Memorandum

File 6-XQ074.04\004

Subject Glenpanel 3 Waters EOI Review Summary

Figure 2 – Glenpanel development area from the EOI

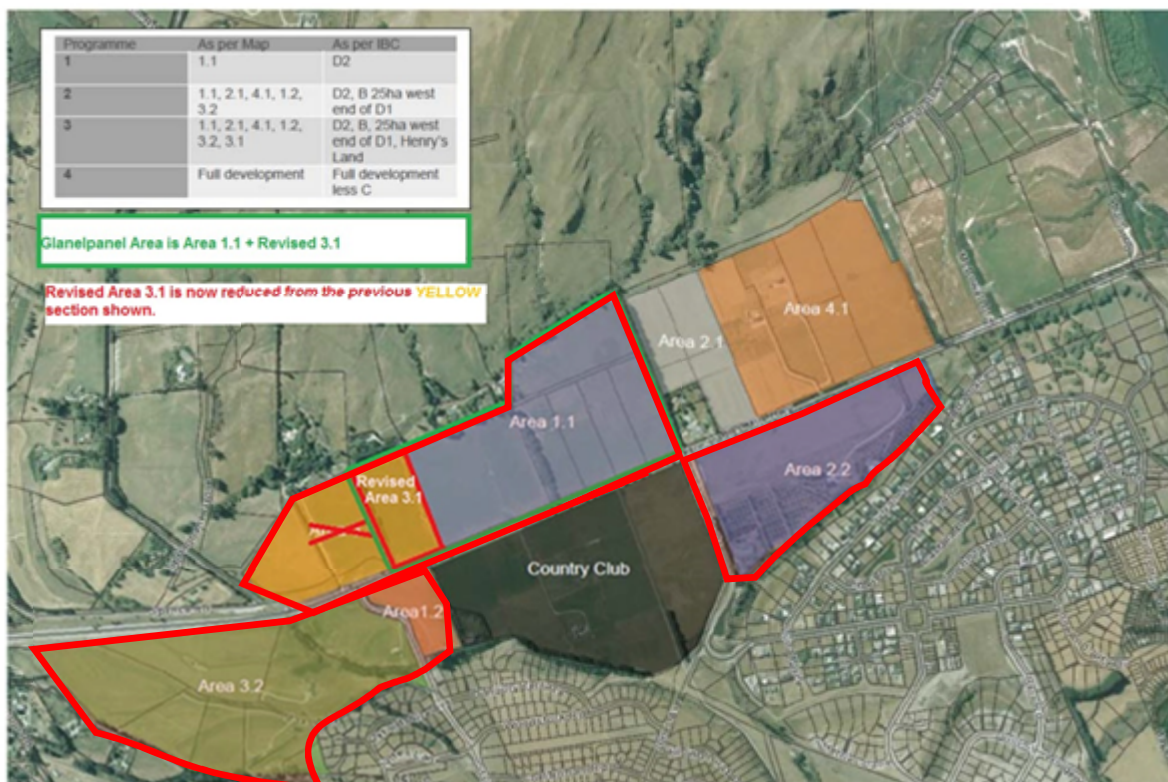
1. As seen in Figure 2, the area of development has increased from that assessed in the HIF project. This is unlikely to make a large difference to the flow that the existing infrastructure can accept, but given the defined capacity of the pipe, understanding the allowable stormwater discharge from this area identified in the original design of the DN1050 pipe would help define the maximum allowable flow it can carry. This in turn will inform the amount of attenuation required within the development.
